Item Name: Crosstube Turning Detail

DART AEROSPACE LTD		Work Order:	96778
Description: Crosstube Assembly (412 Low Aft)		Part Number:	D412-664-249
Inspection Dwg: D412-664-249 Rev: B		Page 1 of 2

DRAWING NO. D412-664-249	TITLE CROSSTUBE ASS'Y (412 LOW AFT)	REV. B	DART AEROSPACE LTD ENGINEERING ORDER		D.E.O. NO. D412-664-249-B-1	SHEET NO. SHEET 1 OF 2	SCALE NTS
DRAWN 9P	CHECKED SC	MFG. APPR. E	APPROVED MD		DE APPR. H		
DATE 11.05.25	DATE 11.05.31	DATE 11.05.31	DATE 11/05/31		DATE 11.05.31

D412-664-249
ASSEMBLY DETAIL

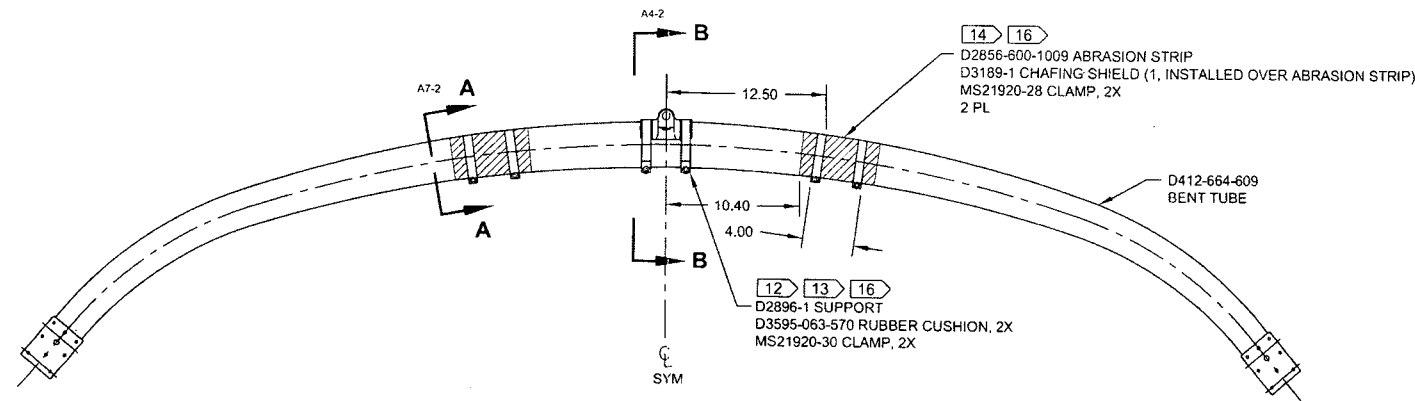
REMOVED ABRASION STRIP IN FAVOR OF A THIN LAYER OF PROSEAL 890.

D3189-1 CHAFING SHIELD (1, INSTALLED OVER PROSEAL 890)
MS21920-28 CLAMP, 2X
2 PL

WAS:

D2856-600-1009 ABRASION STRIP
D3189-1 CHAFING SHIELD (1, INSTALLED OVER ABRASION STRIP)
MS21920-28 CLAMP, 2X
2 PL

D412-664-249
ASSEMBLY DETAIL

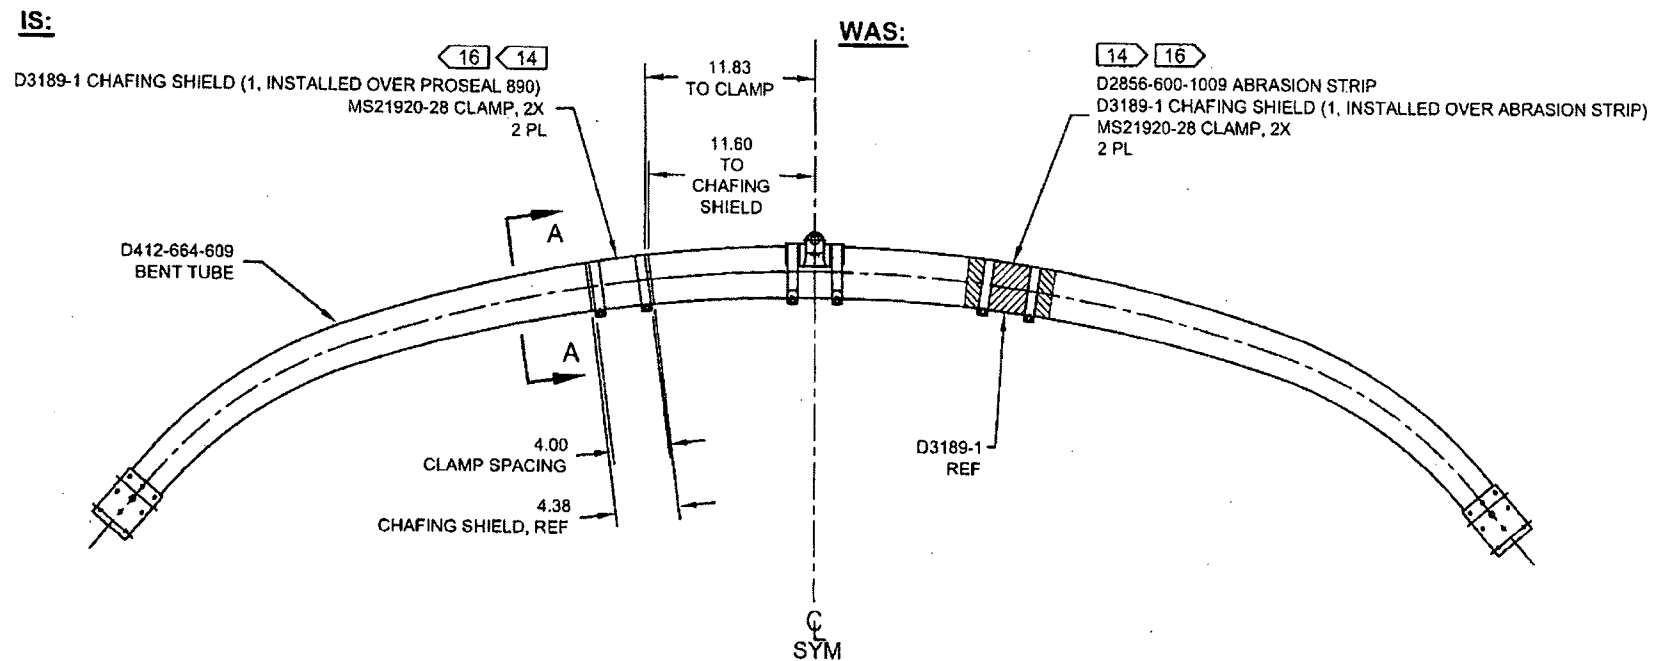
REMOVED ABRASION STRIP IN FAVOR OF A THIN LAYER OF PROSEAL 890. UPDATE INSTALLATION OF CHAFING SHIELDS AND REDUCE TORQUE TO 40-50 IN-LBS. THIS ENGINEERING ORDER SUPERCEDES DEO D412-664-249-B-1

- 14) APPLY A THIN COAT OF PROSEAL 890 ON INSIDE CONCAVE SURFACE OF D3189-1 CHAFING SHIELD AND LET CURE PER MANUFACTURER'S INSTRUCTIONS. INSTALL PROSEALED D3189-1 CHAFING SHIELD ONTO CROSSTUBE BY APPLYING A THIN COAT OF PROSEAL 890 ONTO CROSSTUBE. BE SURE TO ELIMINATE ANY AIR GAPS.
- 16) TORQUE CLAMPS ON D2896-1 SUPPORT 80 TO 100 IN-LB. **TORQUE CLAMPS ON D3189-1 CHAFING SHIELD 40 TO 50 IN-LB.** ENSURE AT LEAST 1.5 THREADS SHOWING IN SAFETY AND THAT NUT HAS NOT BOTTOMED-OUT AFTER TORQUING.
